Bid No.: 24-051

ADDENDUM NO. 1

Flooring Replacement Beals Elementary, Classroom, Hallways, and Offices, Summer 2024

Questions and Clarification for OPS - Beals Elementary Flooring Replacement

Lower Level - Exhibit A

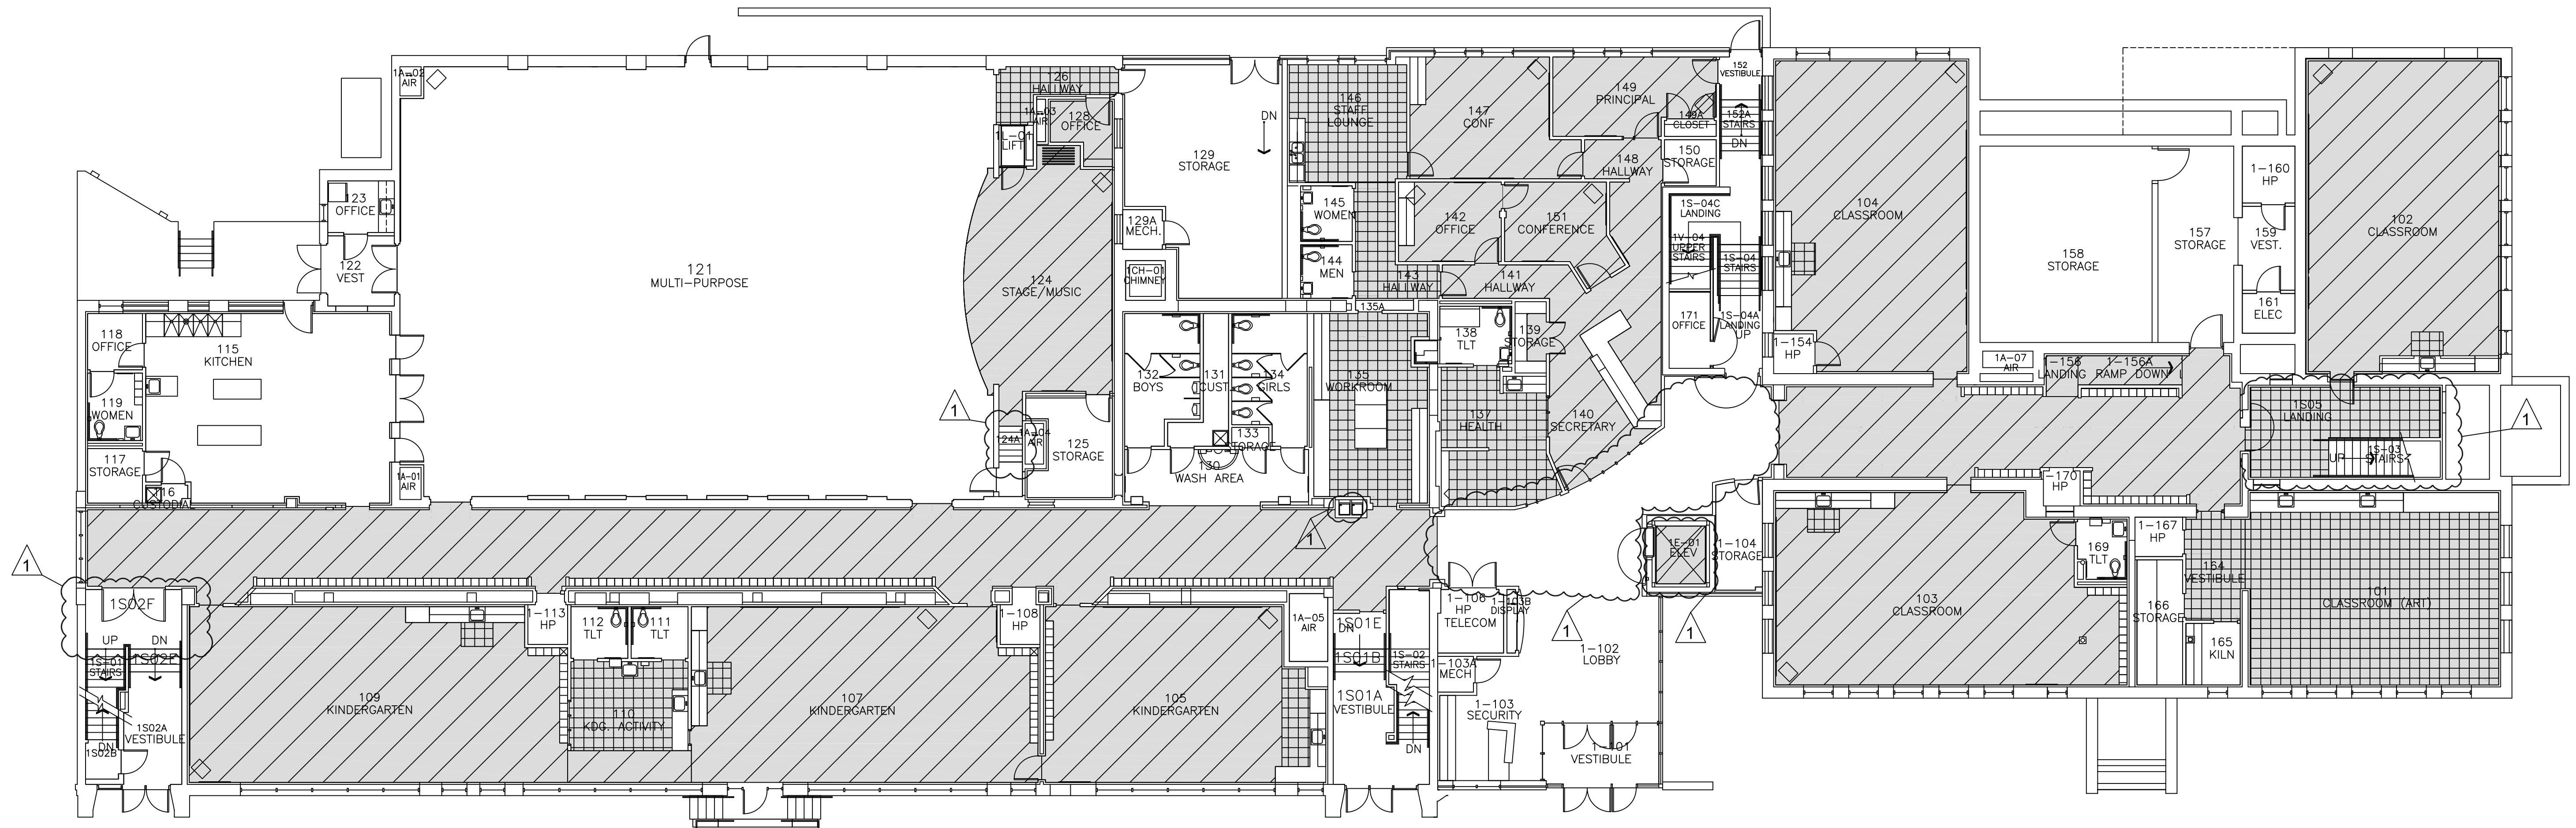
Item 1 - Revised extents of flooring work.

Item 2 - Revised flooring type in some areas.

Q11. Custodial office 011 does not get new carpet tile?

A11. Yes, see revised drawings addendum 1.

2nd Floor Plan - Exhibit C

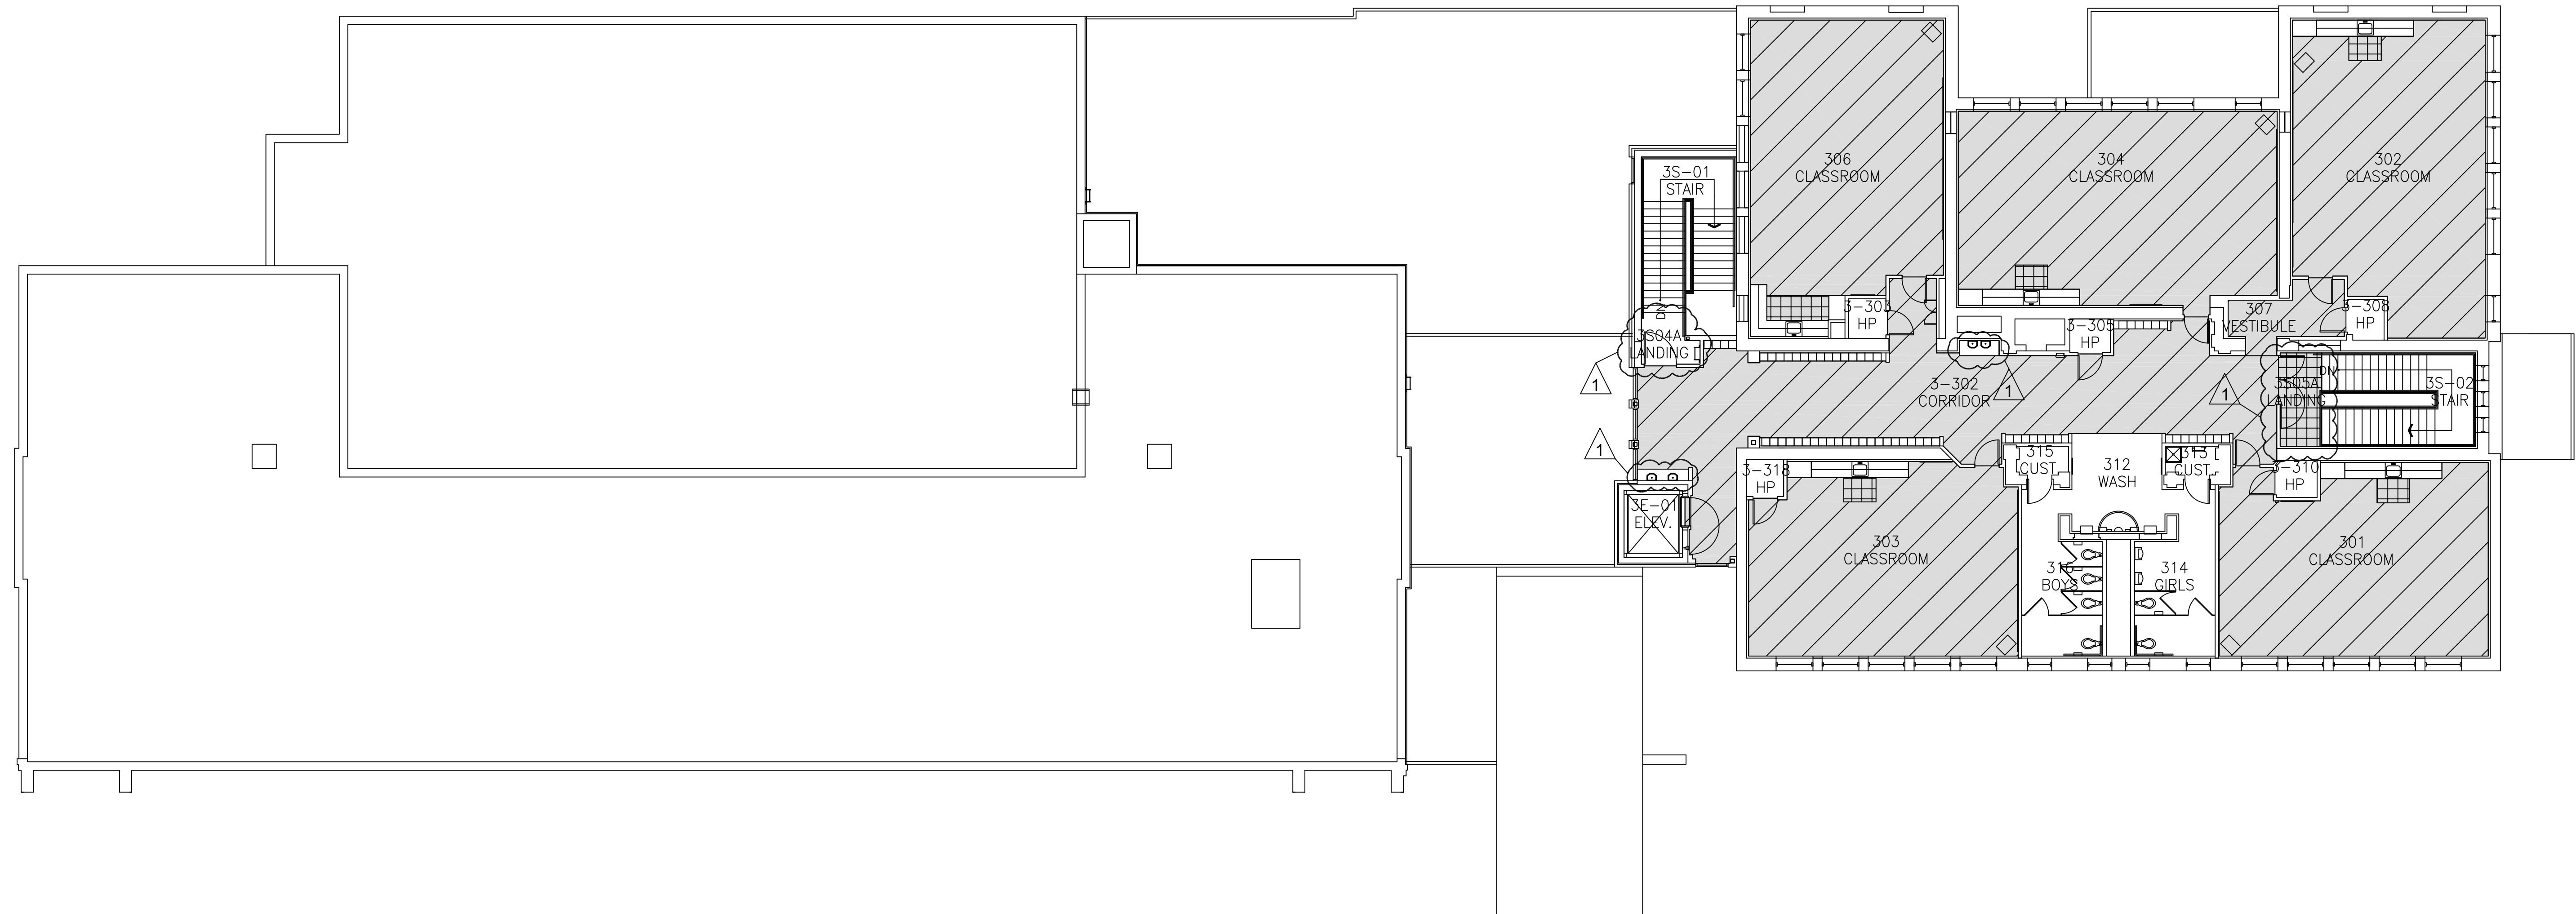
Q2. Carpet Stairs 2-201D is going to stay with carpet tile installation? if so stair nosing should be used. Please specify specs on stair nosing

Q4. Landing 2S05A is going to have VCT installed instead of Carpet tile? Please confirm

Q5. Rooms 202 & 226 have bolted in shelving. Are the shelving units going to be removed or staying?

A2. Install broadloom carpet on stairs at 2-201D, See addendum 1.

A4. Yes, install VCT at Landing 2S05A. See addendum 1.

A5. Existing wall shelving will remain in place. Terminate carpet removal and installation at existing shelving.
